Access Compliance Report

Public Rights-of-Way (Curb Ramps)

Intersection ID: 15450	Main Street: ALBEMARLE_RD	Cross Street: PIERSON_DR	Location: NW
ADA ID: 19FF28085775	Ramp Type: Perp	Initial Pass/Fail: Fail	Overall Compliance: No
Codes/Mitigation Info/Possible Solution		Field Measurements/Component Compliance	
Severity Score: 22.5

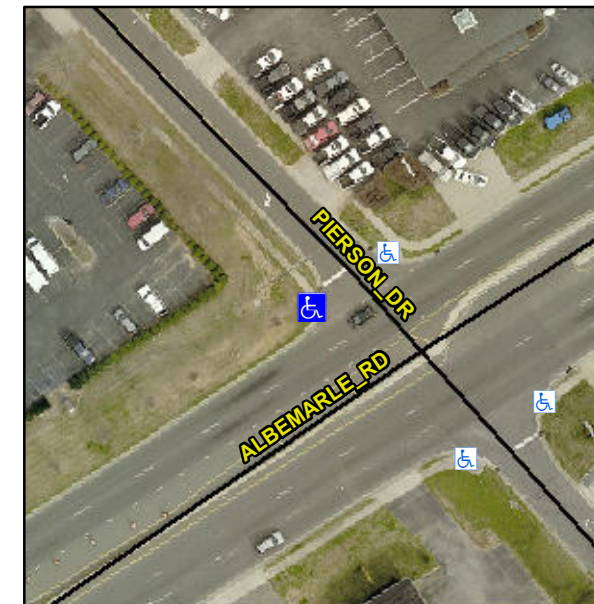
Not Found, R304.5.1, R304.2.2, R304.5.3

Compliance	Description	Data	Compliance	Description	Data
N/A	Ramp Length (in)	75.0	No	Ramp Slope (%)	8.8
No	Ramp Width (in)	45.0	No	Ramp XSlope (%)	4.6
N/A	Flare Type LT	N/A	N/A	Flare Type RT	N/A
N/A	Flare Slope LT (%)	N/A	N/A	Flare Slope RT (%)	N/A
N/A	Flare Traversable LT?	N/A	N/A	Flare Traversable RT?	N/A
N/A	Landing Length (in)	N/A	N/A	DWS Provided?	N/A
N/A	Landing Width (in)	N/A	N/A	DWS Contrast?	N/A
N/A	Landing Slope (%)	N/A	N/A	DWS Length (in)	N/A
N/A	Landing X Slope (%)	N/A	N/A	DWS Full Width?	N/A
N/A	Landing Curb? (Y/N)	N/A	N/A	DWS Offset (in)	N/A
N/A	Shared Landing?	N/A			
N/A	Gutter Ponding?	N/A	N/A	Gutter Slope (%)	N/A
N/A	Gutter Lip Ht (in)	N/A	N/A	Gutter X Slope (%)	N/A
N/A	Painted X Walk1?	No	N/A	Painted X Walk2?	N/A
	X Walk 1 Direction	To NE		X Walk 2 Direction	N/A
N/A	X Walk 1 Width (in)	N/A	N/A	X Walk 2 Width (in)	N/A
	X Walk 1 Slope (%)	3.0		X Walk 2 Slope (%)	N/A
	X Walk 1 X Slope (%)	2.5		X Walk 2 X Slope (%)	N/A

Remove & Replace Entire Ramp.
